The Commission has issued the enclosed Amendment No. 24 to Facility Operating License No. DPR-71 and Amendment No. 48 to Facility Operating License No. DPR-62 for the Brunswick Steam Electric Plant (BSEP), Units Nos. 1 and 2, respectively.

BRUNSWICK STEAM ELECTRIC PLANT, UNIT NO. 1

Amendment No. 24
License No. DPR-71

Amendment No. 48
License No. DPR-62

FUEL TYPE 8DRB265
MAXIMUM AVERAGE PLANAR LINEAR HEAT
GENERATION RATE (MAPLHGR)
VERSUS AVERAGE PLANAR EXPOSURE

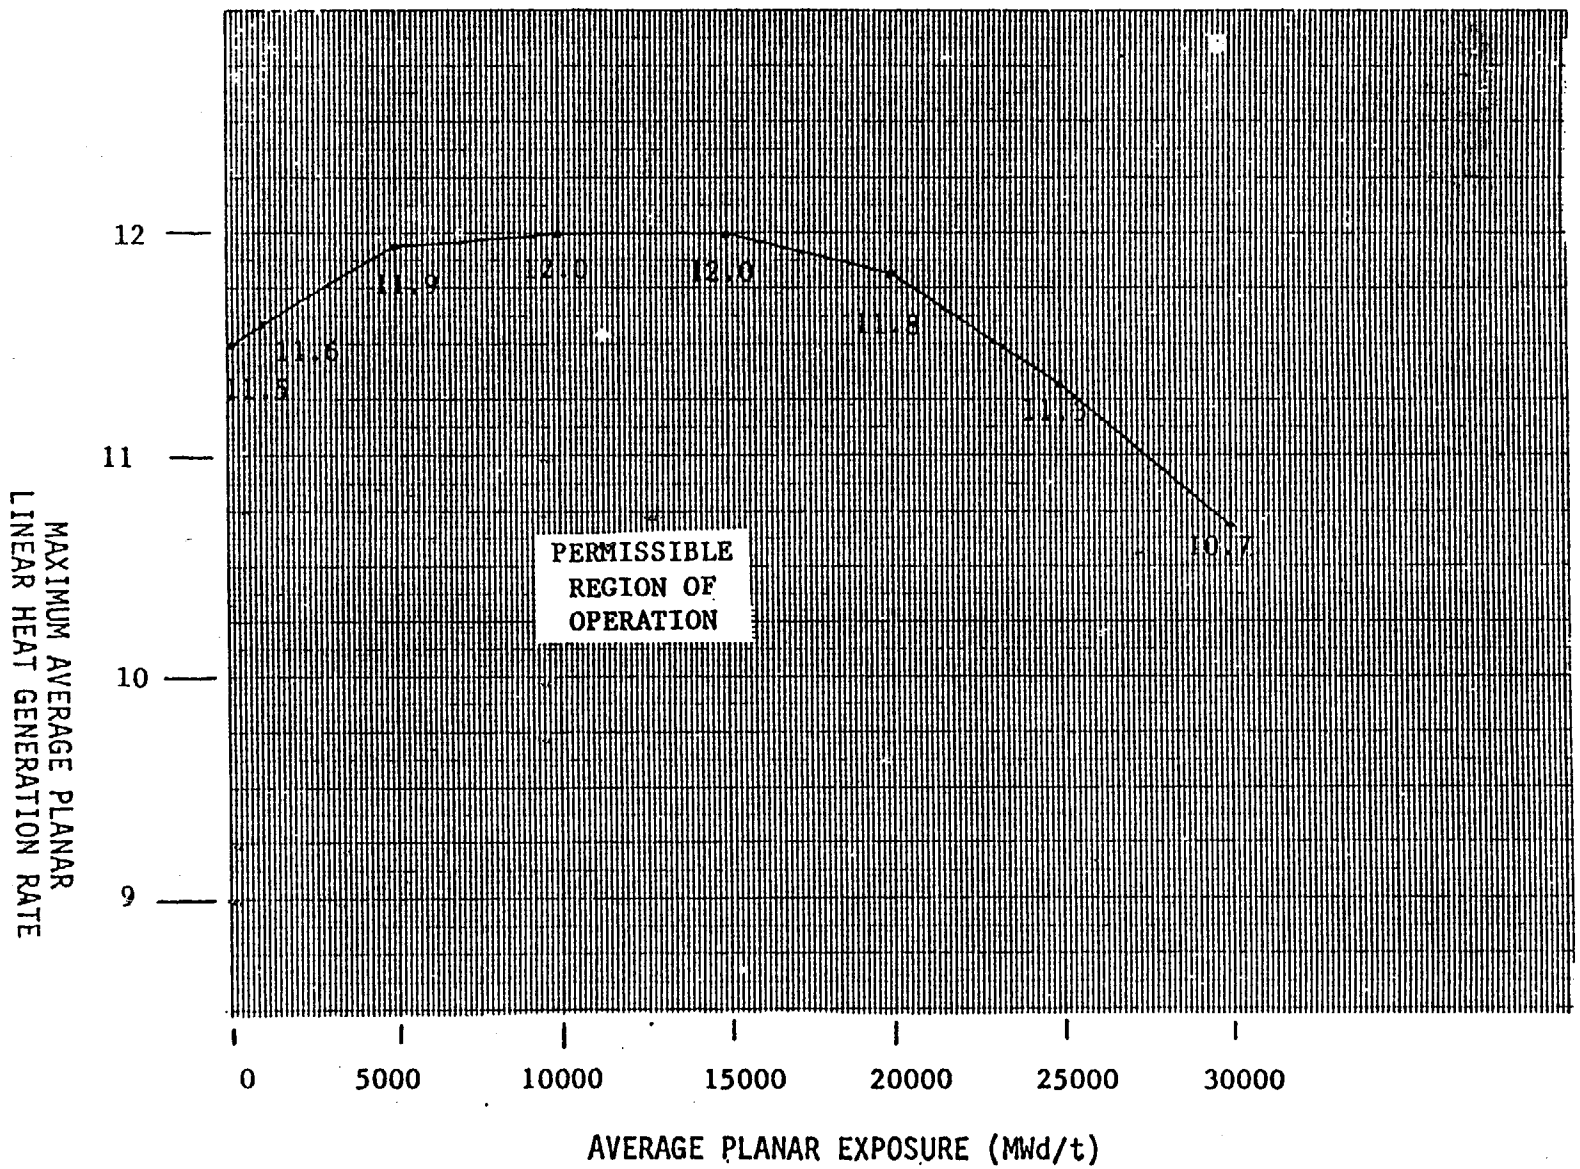
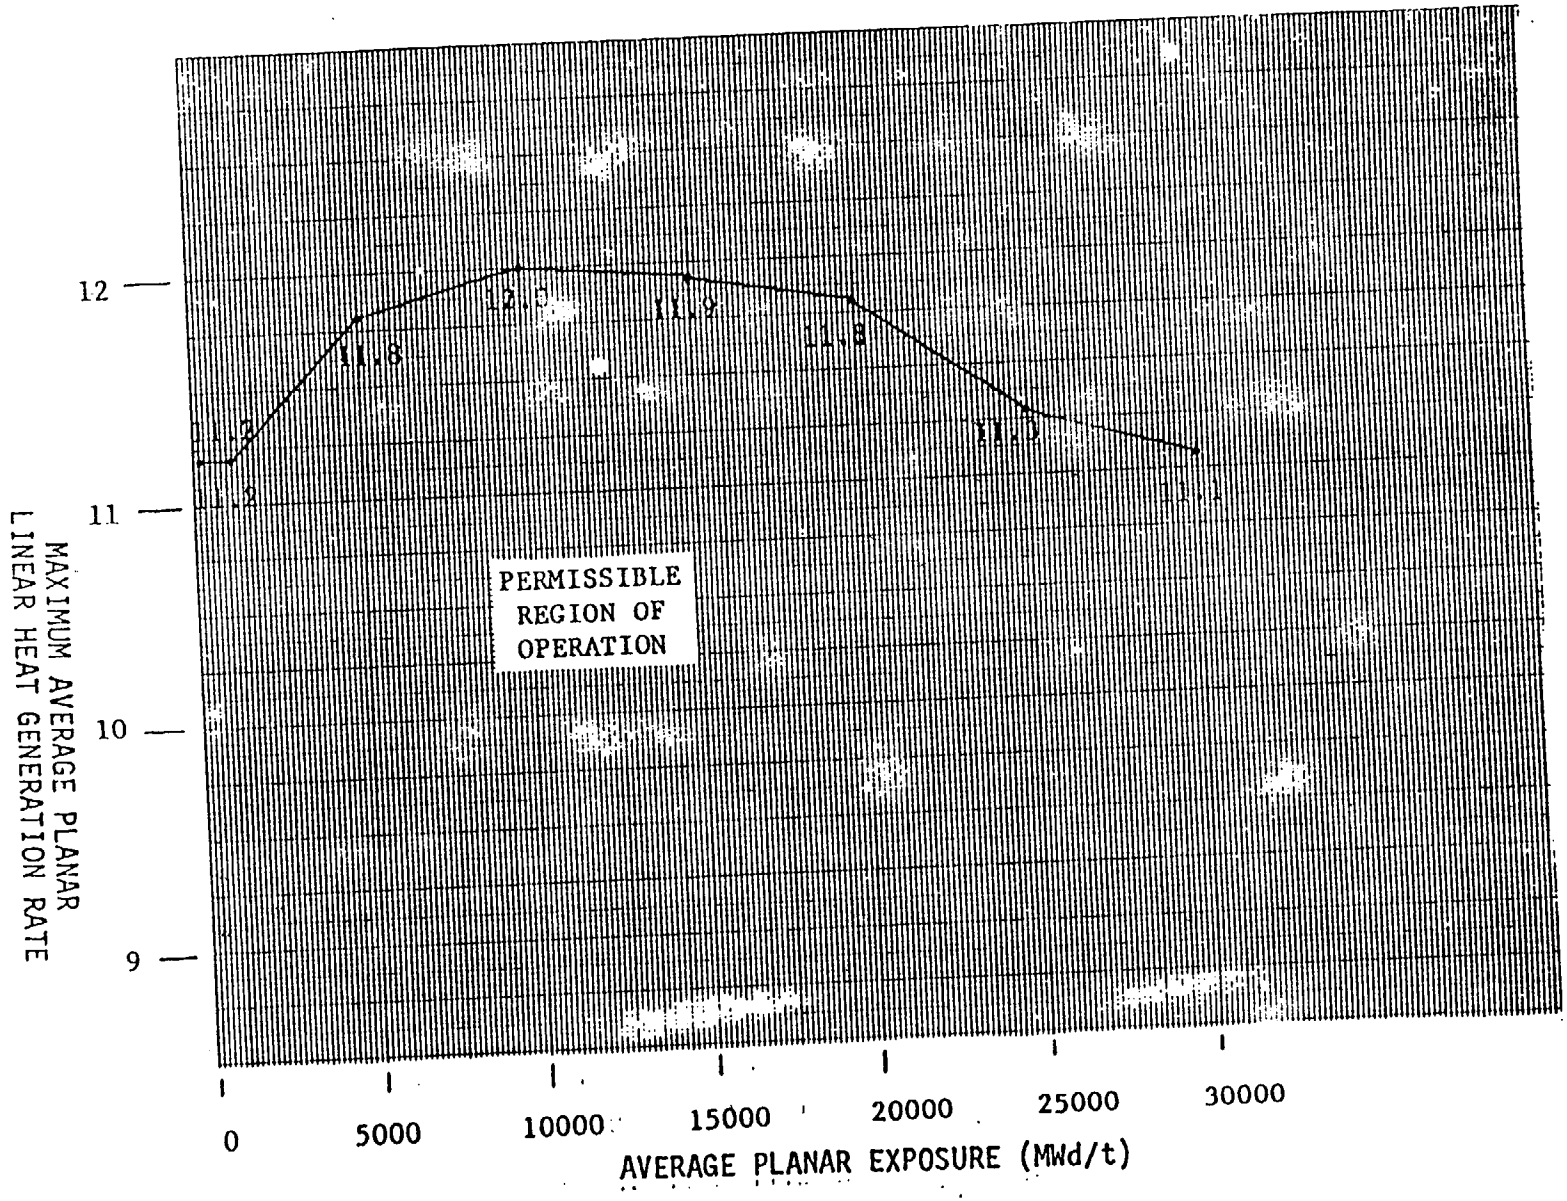
3.2.1 All AVERAGE PLANAR LINEAR HEAT GENERATION RATES (APLHGR's) for each type of fuel as a function of AVERAGE PLANAR EXPOSURE shall not exceed the limits shown in Figures 3.2.1-1, 3.2.1-2, 3.2.1-3, 3.2.1-4, 3.2.1-5, 3.2.1-6 or 3.2.1-7.

We have reviewed the information submitted by the licensee and conclude that all requirements of 10 CFR 50.46 and Appendix K to 10 CFR 50.46 will be met when the reactor is operated in accordance with the MAPLHGR versus Average Planar Exposure values given in Figures 3.2.1-1, 2, 3, 4, 5, 6, and 7 of the Technical Specifications.

FIGURE 3.2.3-1

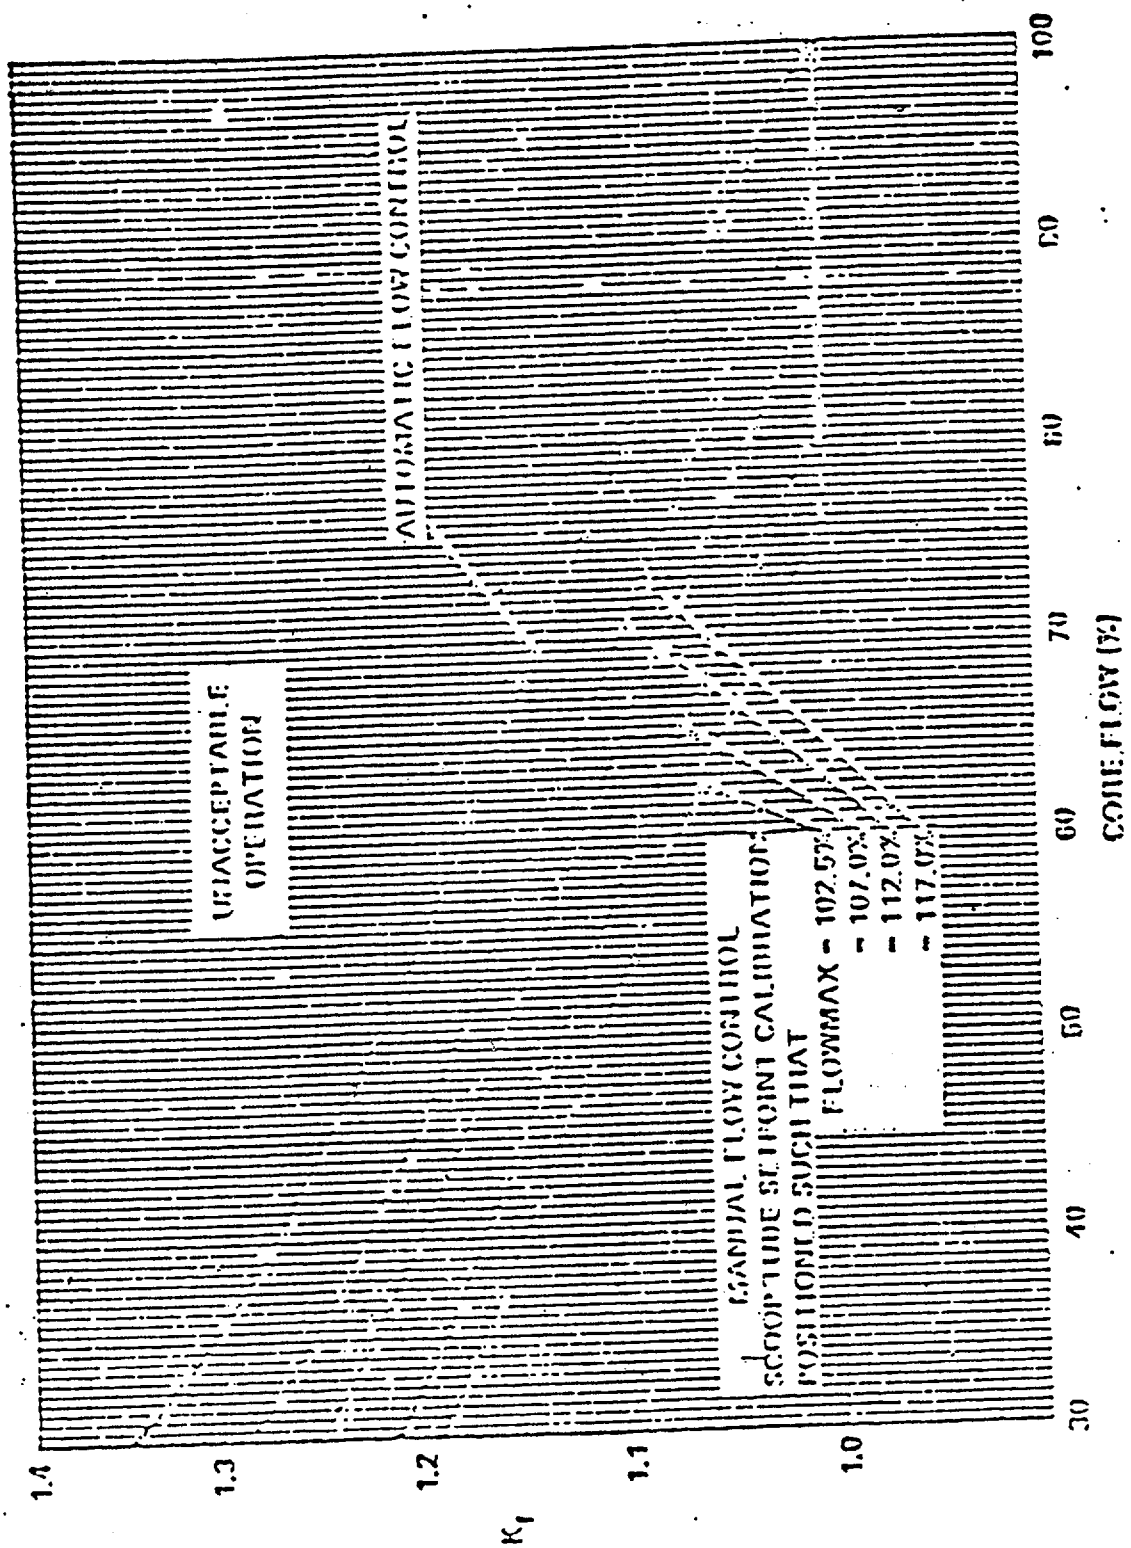
The K_f factor values shown in Figure 3.2.3-1 were developed generically which are applicable to all BWR/2, BWR/3, and BWR/4 reactors. The K_f factors were derived using the flow control line corresponding to rated thermal power at rated core flow.

The K_f factors shown in Figure 3.2.3-1 are conservative for the General Electric Plant operation with 8 x 8 and 8 x 8R fuel assemblies because the operating limit MCPR's of Specification 3.2.3 are greater than the original 1.20 operating limit MCPR used for the generic derivation of K_f. The k_f curves are conservative for 7 x 7 fuel whenever the operating limit MCPR is greater than 1.23 as documented in Appendix C of NEDE 24011-P-A. A correction to the K_f curves is, therefore, necessary whenever the MCPR for the 7 x 7 fuel is equal to or less than 1.23 in order to ensure that the fuel cladding integrity Safety Limit is not violated. This correction is made by using a scoop tube set point of 102.5%. The MCPR for 7 x 7 fuel is then the product of the value given in Specification 3.2.3 and the K_f curve based on 112% as shown in Figure 3.2.3-1. Whenever the MCPR for the 7 x 7 fuel is greater than 1.23, this correction is not applied.

*For the 7x7 fuel, the 102.5% core flow K_f curve is nonconservative (Reference 6) with operating limits <1.23. Therefore, at reduced flow conditions, the K_f factor for the 7x7 fuel assemblies will be based on the 112% flow curve of Figure 3.2.2-1 of the Technical Specifications rather than the actual setpoint of 102.5%.
